ADDENDUM 2 – BID PACKAGE 2 PHASE B, C, D

DATE: January 12, 2022 M2 PROJECT #: 201001

PROJECT: Greater Peoria Mass Transit

GPMTD CITYLINK NEW MAINTENANCE FACILITY & RENOVATION: PHASES B, C & D

Sheet Number
G-008

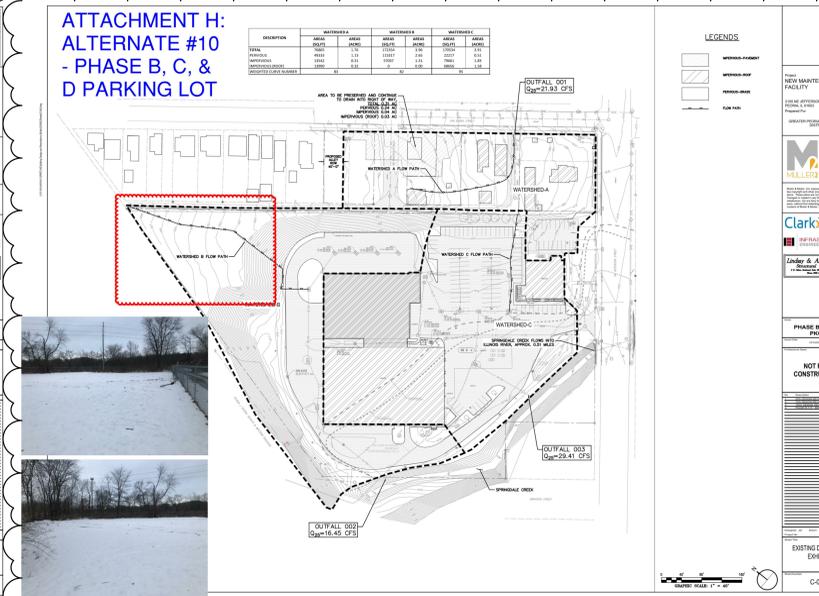
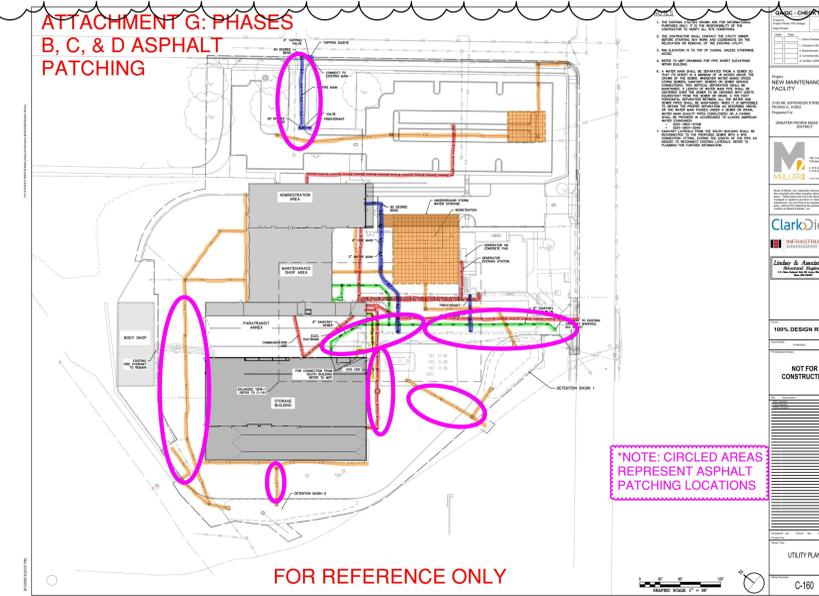
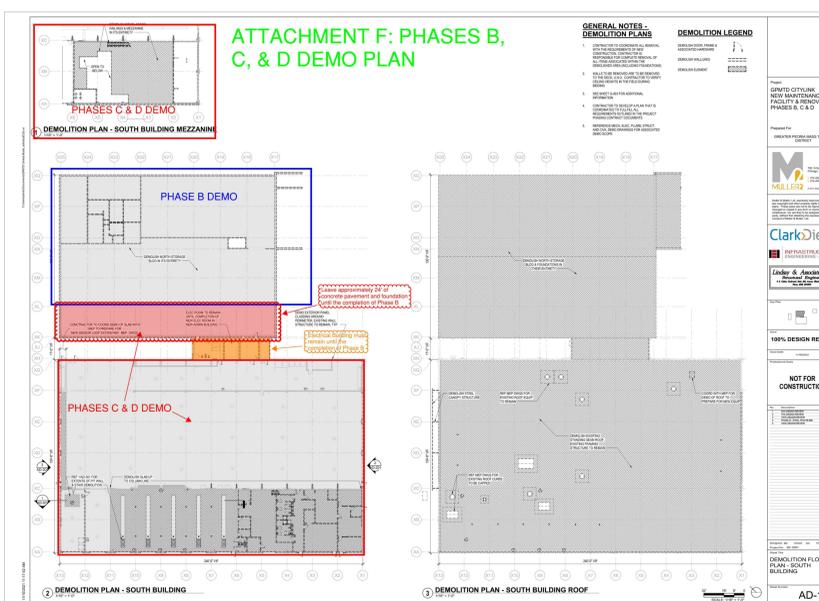
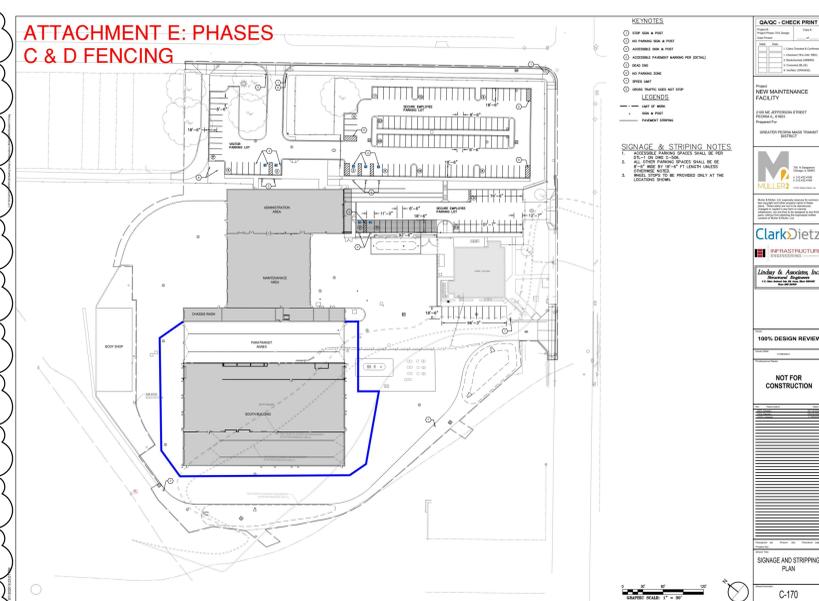
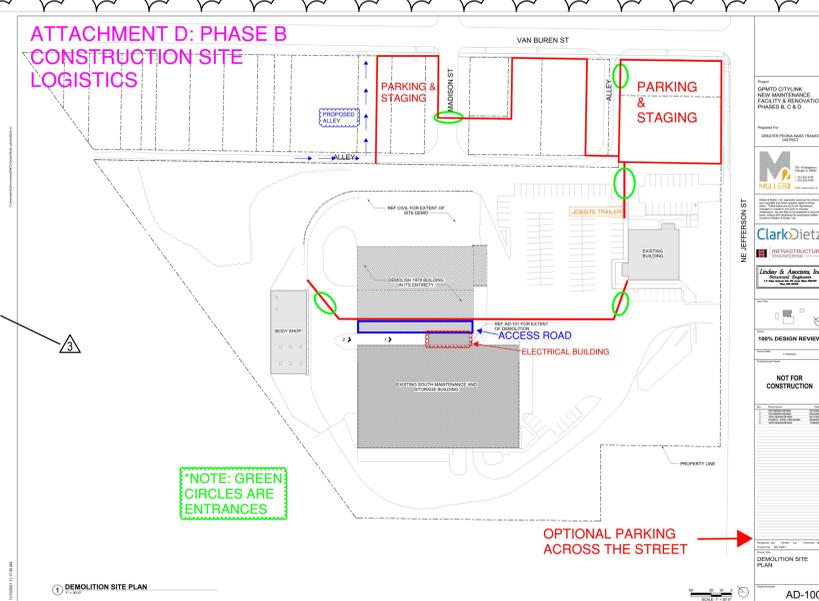
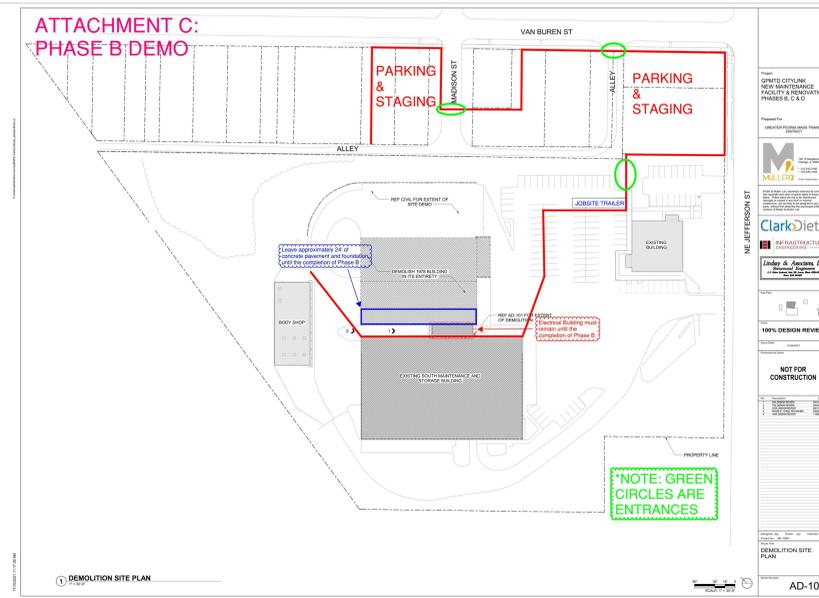
Q: Alternate to be added for the north west lot by the railroad tracks to be set up for the ConEx storage containers.

1. See Attached Cover Sheet G-001 Issued for Addendum 2
2. See Attached G-002 Sheet Index for Addendum 2
3. See Attached G-008 Sheet with added Alternate # 10 Northwest Parking/ Staging Area and revised Phase B – Construction Site Logistics Plan.
4. See attached Substitution request forms and PDF attachments from Summit lockers.

A: Alternate #_: North West Lot: This alternate is for staging large ConEX Boxes for storage. Putting gravel base down on the North West lot, located by the railroad tracks. A new temporary gate will be needed for access.
